RE: BUILDING WORKS TO AN EXISTING DWELLING HOUSE (HERITAGE) UPON LAND AT 38 MORETON STREET, NEW FARM (COUNCIL REFERENCE A007129284)

We write in relation to the abovementioned application and Council's Information Request dated 03 November 2026.

Figure 2: Updated Southwestern Elevation

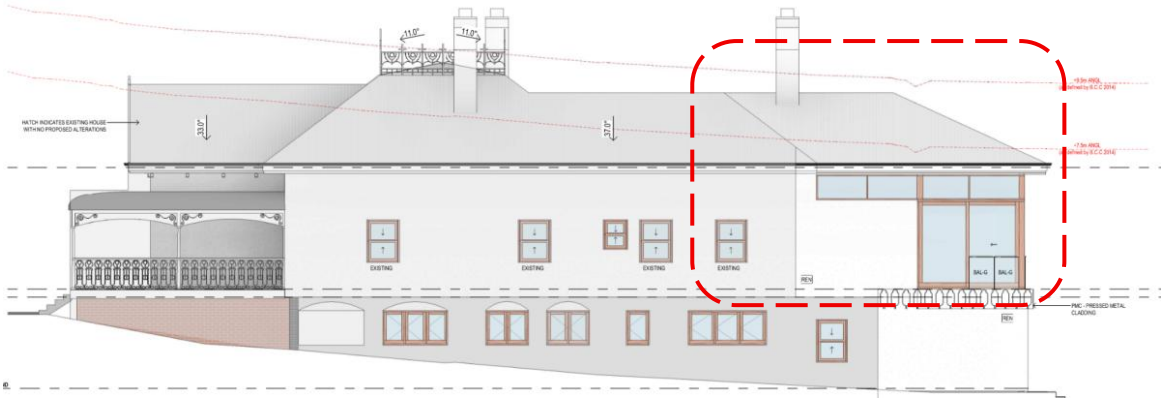
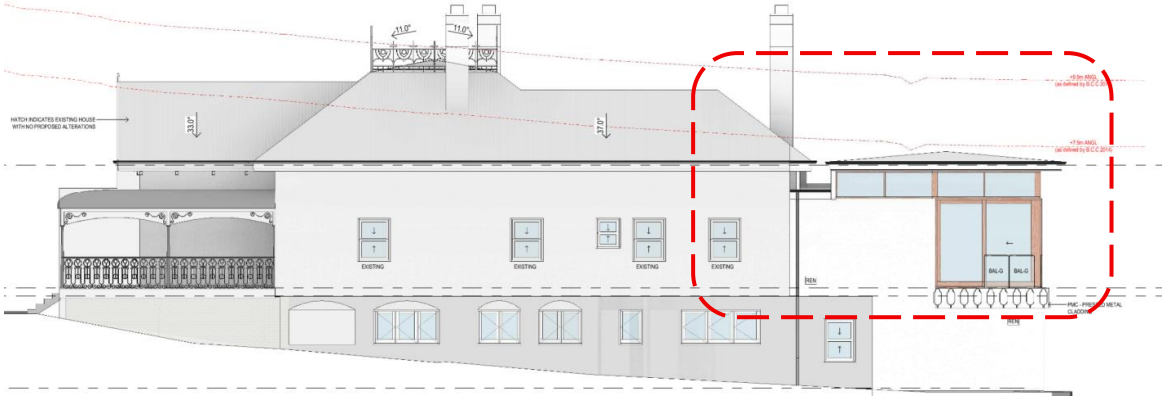
The proposed rear addition alters the original asymmetrical hipped roof form of the Local heritage place and is considered to diminish the aesthetic significance of the dwelling as one of a group of four identical asymmetrical residences, as identified under Criterion E of the Statement of Significance in Council's heritage citation. The proposal is therefore not considered to achieve performance outcomes PO1, PO2, PO3 and PO4 of the Heritage overlay code. To address this:

a) Provide amended plans showing the proposed rear addition redesigned to remain below the rear eave line of the original building and retain the original asymmetrical hipped roof form, thereby maintaining the built form and aesthetic significance of the Local heritage place.

In response to Council's comments, an updated set of Architectural Plans has been prepared by *Invilla Architects*, incorporating a reduction in the height of the proposed rear addition. The updated design also incorporates a box gutter connecting the existing Dwelling and the extension, ensuring that the original rear hipped roof sheeting, chimney, and corbels are retained and remain visually prominent. The amended design ensures that the addition sits below the rear eave line of the original building and retains the original asymmetrical hipped roof form, thereby better maintaining the established built form and aesthetic significance of the Local heritage place.

Figure 4: Updated Demolition Plans – Roof Sheet

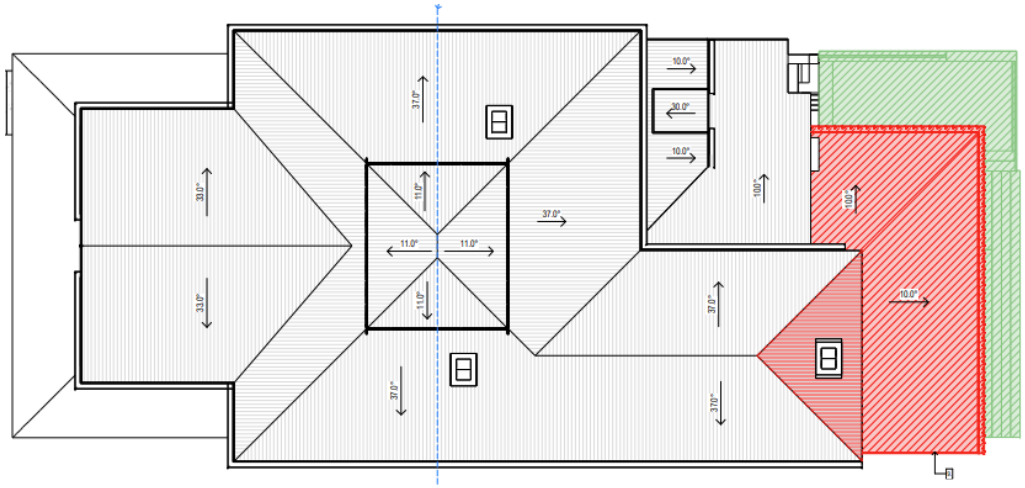
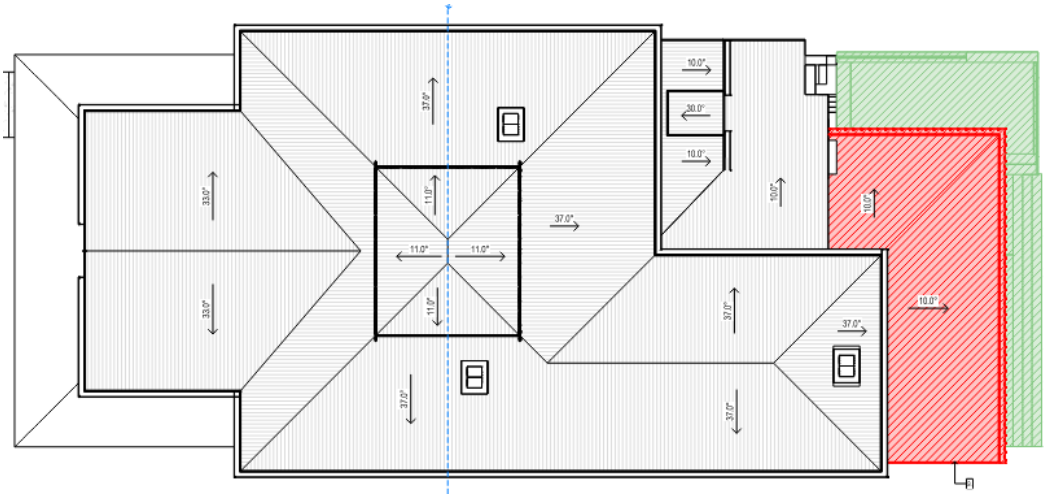
The amended roof configuration also allows for an overall reduction in the extent of proposed demolition, with the entirety of the rear hipped roof being retained. Refer to Figure 2- Figure 5 below for a comparison of the original and amended designs.
